(Huntsman's Ridge)
HOWARD COUNTY SANITARIUM
VARIANCE PETITION

RE: VP-87-81, Huntsman's Ridge

HUNTSMAN'S RIDGE

F-87-184

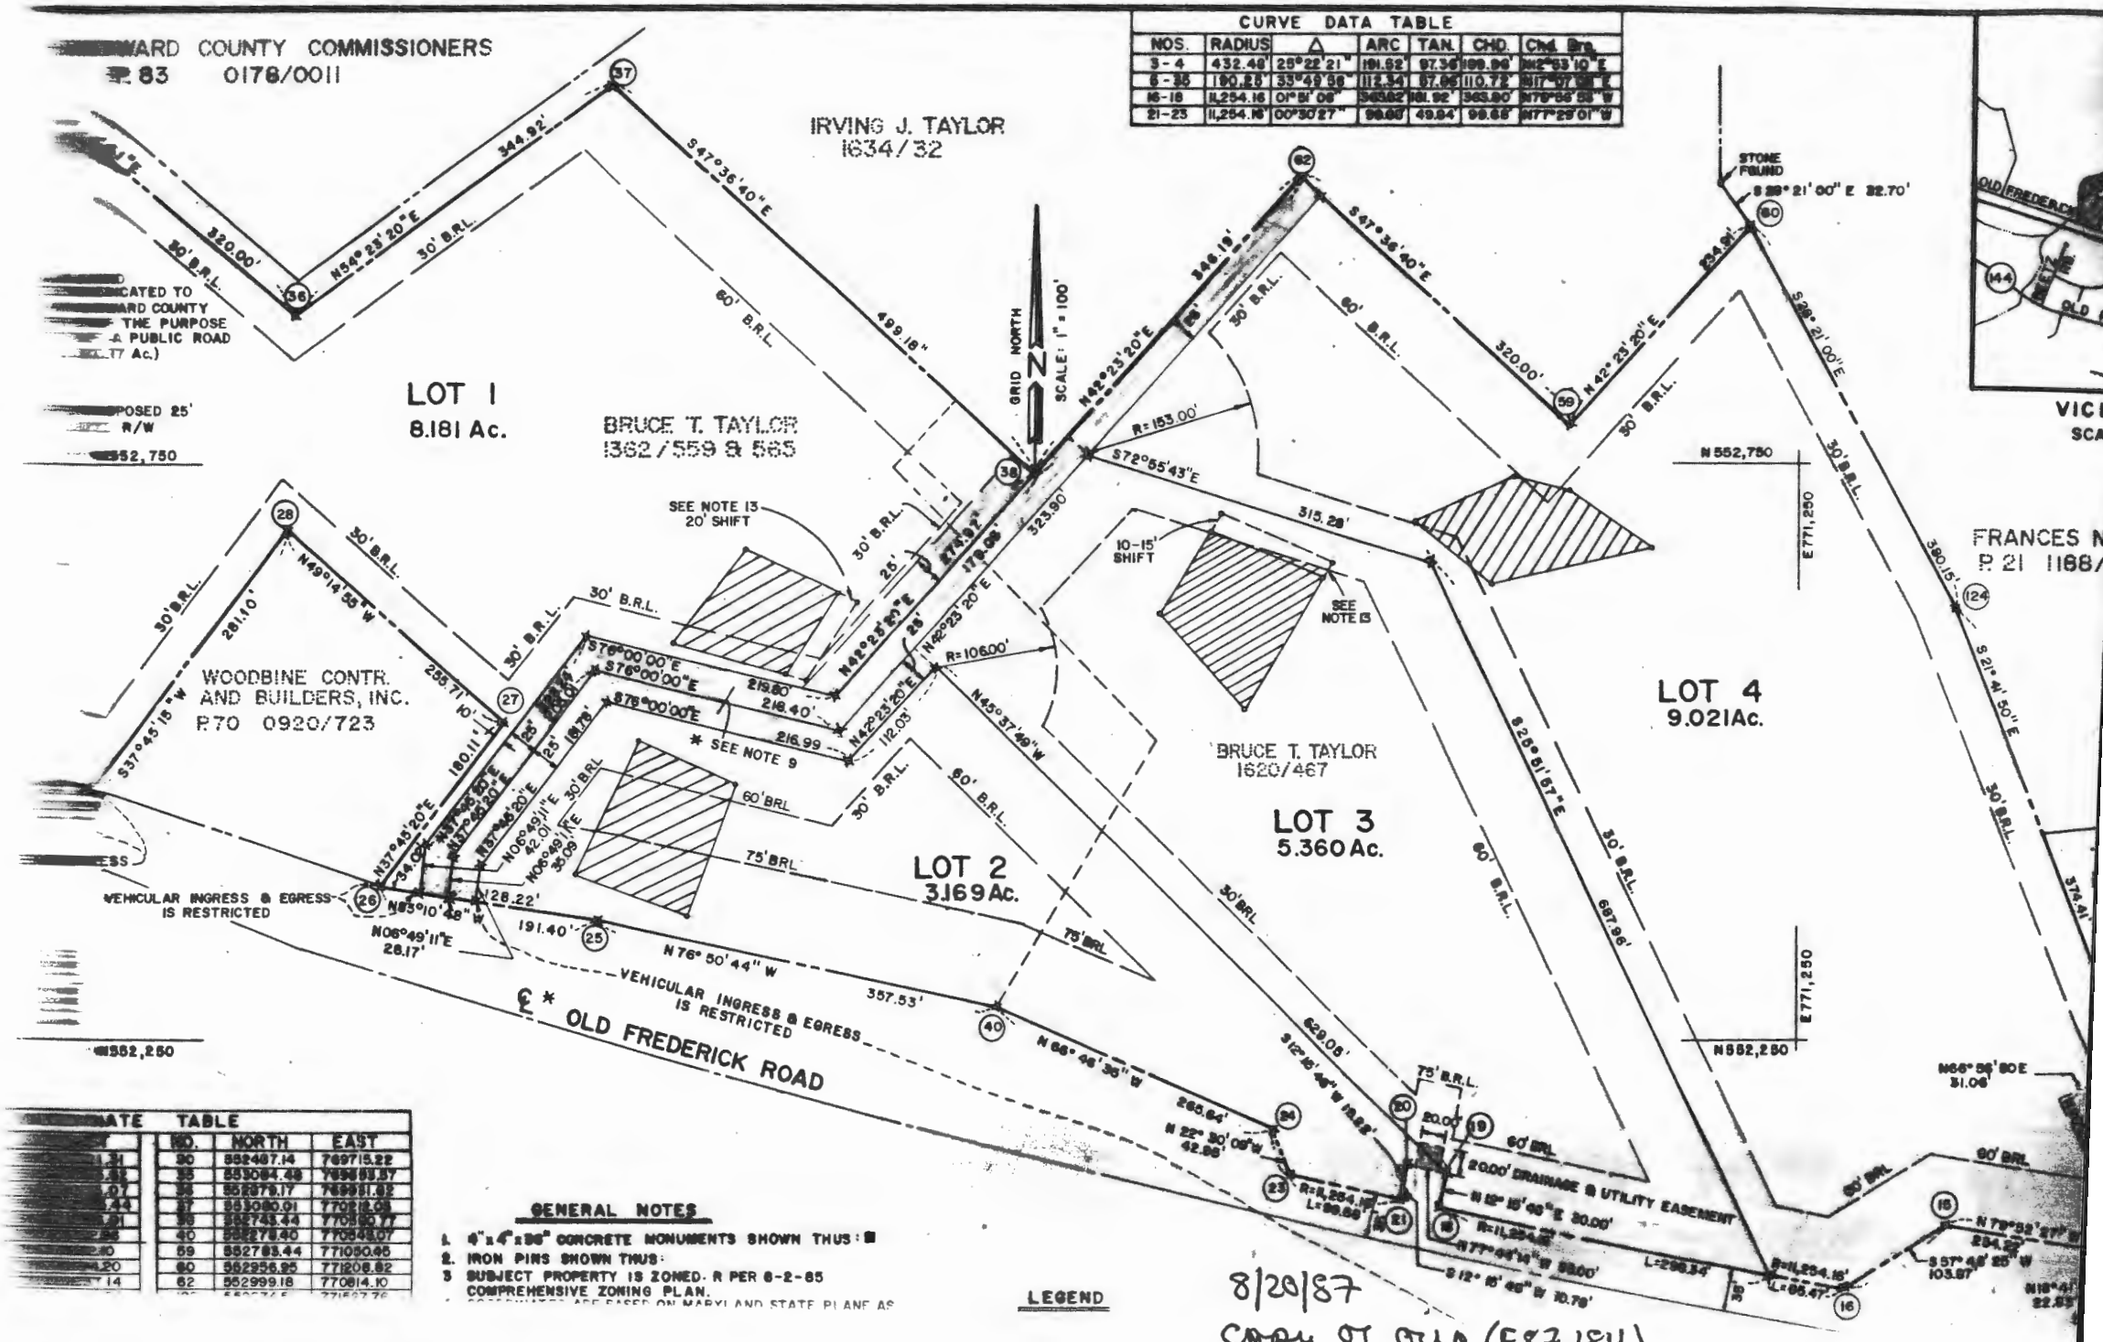
This office recommends denial from Section 113.7.a.(2) of the Howard County Subdivision and Land Development Regulations since the proposed road does not provide adequate collection.

The parcel consists of forty-seven (47) acres therefore the subdivision consists of three (3) lots requiring two (2) lots to be developed through major subdivision procedures. Provide public road off Route 99 to serve the proposed lots and the remaining parcel.
